GROUP
Fuel

MODEL
2017MY~
Sportage (QL)

NUMBER
PS532 (Rev 1, 12/05/2018)

SUBJECT: DTC P0449 VENT VALVE/SOLENOID CIRCUIT &
P2422 VENT VALVE STUCK CLOSED

Fuel Tank Evaporative System (QL)

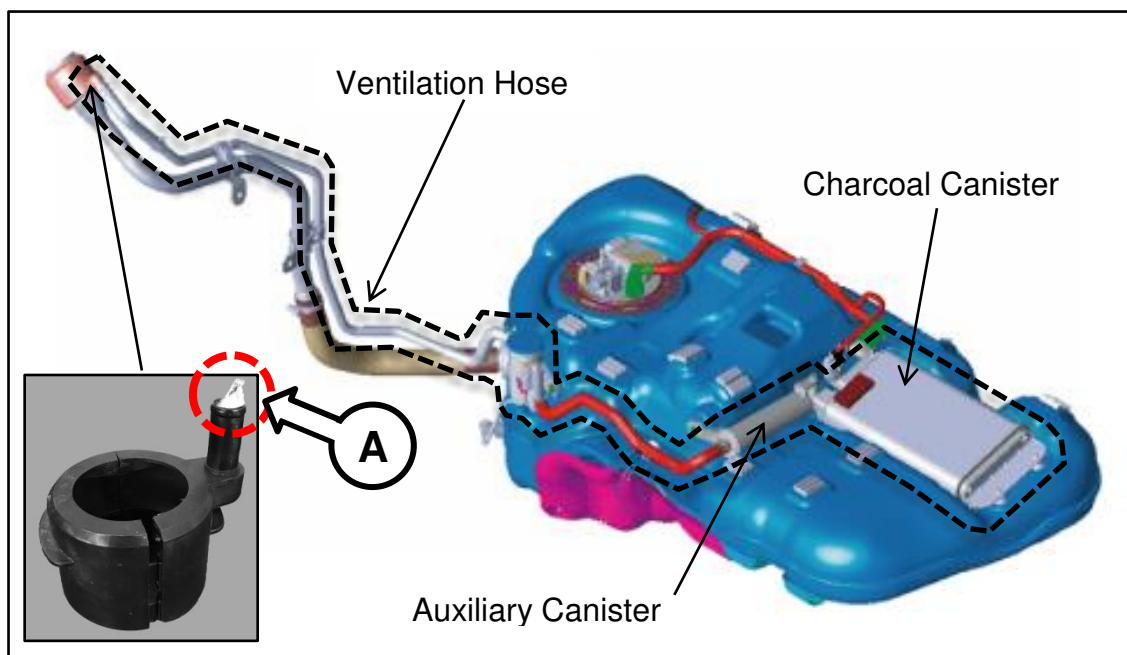
If a foreign object is found anywhere from the filler neck to the main charcoal canister, such as a spider nest (A), the object will need to be removed with a pipe cleaner. Trying to clear the hose with compressed air has proven to be ineffective and should not be done. The most common area of spider nest presence is located at the filler neck.
